CALICE - Additional Information For The PPRP

February 23, 2005

Prof. G. P. Heath provided us with feedback and specific questions which we answer below.

Figure 1: *ECAL linearity (left) and resolution (right) as a function of the incident electron energy, for differing MAPS pixel sizes (in μm) and the diode pad option (Analogue).*

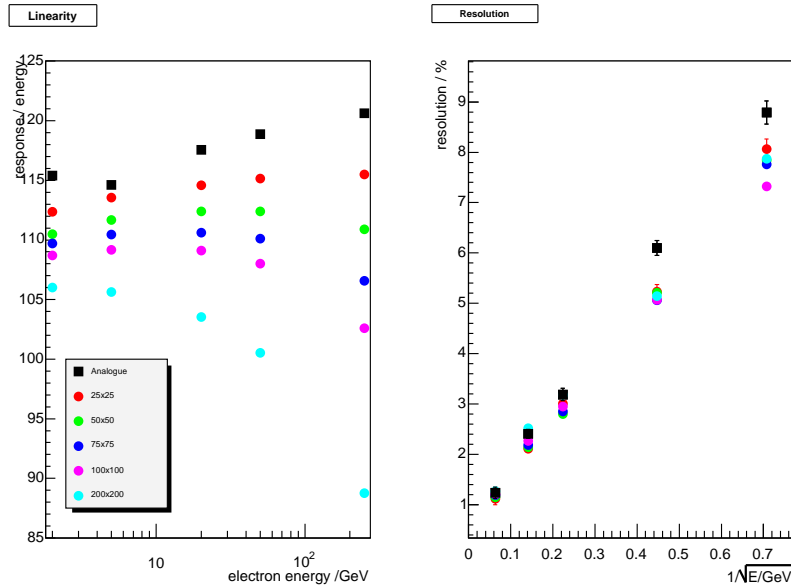
- (a) *Surely the pad size of the detector is controlled by the Molière radius of $W \sim 10$ mm? Why do you want 10^4 times the granularity? What is really gained in terms of the physics?*

The pixel size for MAPS is not driven by the wish to separate close-by showers more efficiently. The motivation for having small pixels is to reduce the probability of more than one charged particle passing through each pixel to a low level. The concept is that the pixels have binary readout, so the only information available is whether a charge consistent with a MIP (or more) was deposited. The necessary pixel size is explained on page 24 of the Case For Support and slide 17 of P.D.Dauncey’s talk; the EM shower density of ~ 100 particles per mm^2 means pixel sizes of around $50 \times 50 \mu\text{m}^2$ are needed. Larger pixels will have a higher probability of multiple particles and so will lead to saturation effects. This is shown in Figure 1 where the linearity and resolution determined from simulation are shown for several choices of pixel size.

In fact, as shown in Figure 7 of the Case For Support, the smaller pixel size also does appear to improve the two particle separation. Although the pixel size is well below the Molière radius of 9 mm, this radius is really only meaningful several radiation lengths into the shower, when it has had time to spread. In the first few layers of the calorimeter, the shower is significantly narrower; with pixels, these first layers allow a better separation than for the large diode pads; they effectively act as a preshower detector.
